RENESAS TECHNICAL UPDATE

Product Category	Transistor		Document No.	TN-WTR-A001A/E	Rev.	1.00
Title	LFPAK, LFPAK-i Packing Specification Change		Information Category	Packing Change		
Applicable Product	LFPAK and LFPAK-i Package	Lot No.	Reference Document	-		
		-

Renesas Technology will change the packing specification for LFPAK and LFPAK-i.

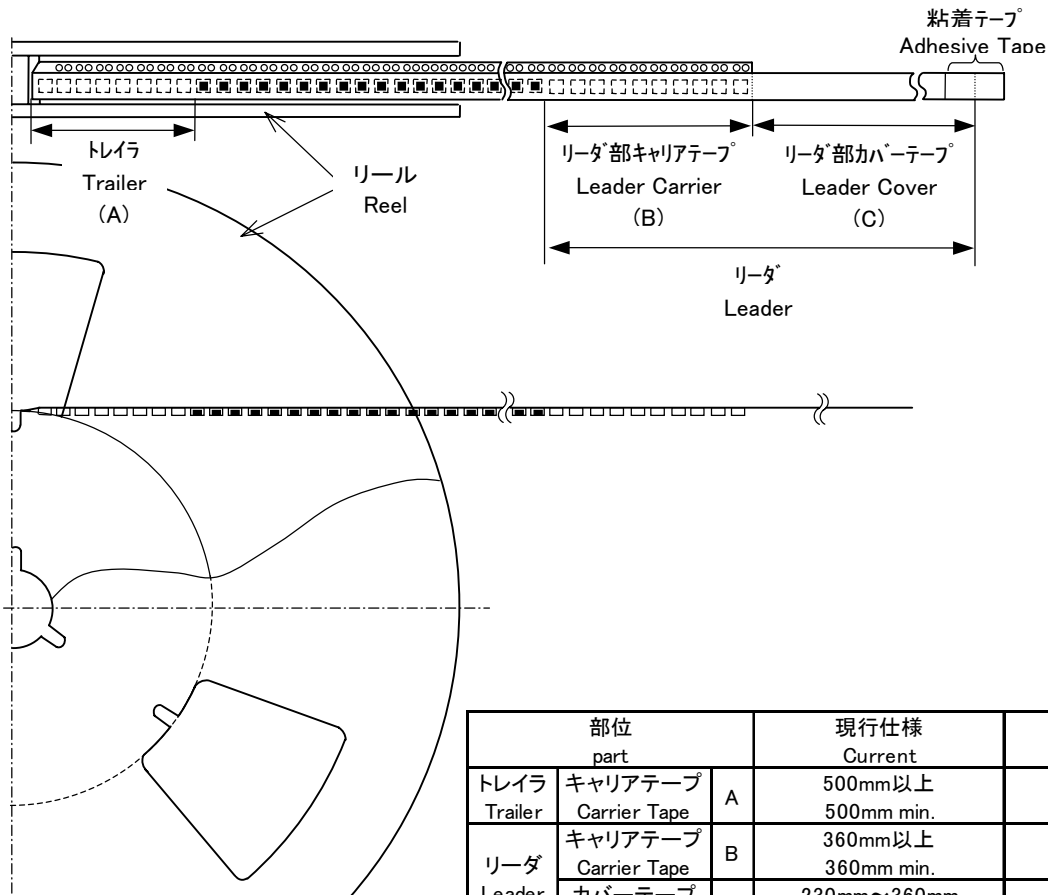
3. Changing of Packing

Old and new specification are as follow

部位 part			現行仕様 Current	新仕様 New
トレイラ Trailer	キャリアテープ Carrier Tape	A	500mm以上 500mm min.	150mm以上 150mm min.
	キャリアテープ Carrier Tape	B	360mm以上 360mm min.	150mm以上 150mm min.
リーダ Leader	カバーテープ Cover Tape	C	230mm~360mm 230mm min. 360mm max.	230mm~360mm 230mm min. 360mm max.
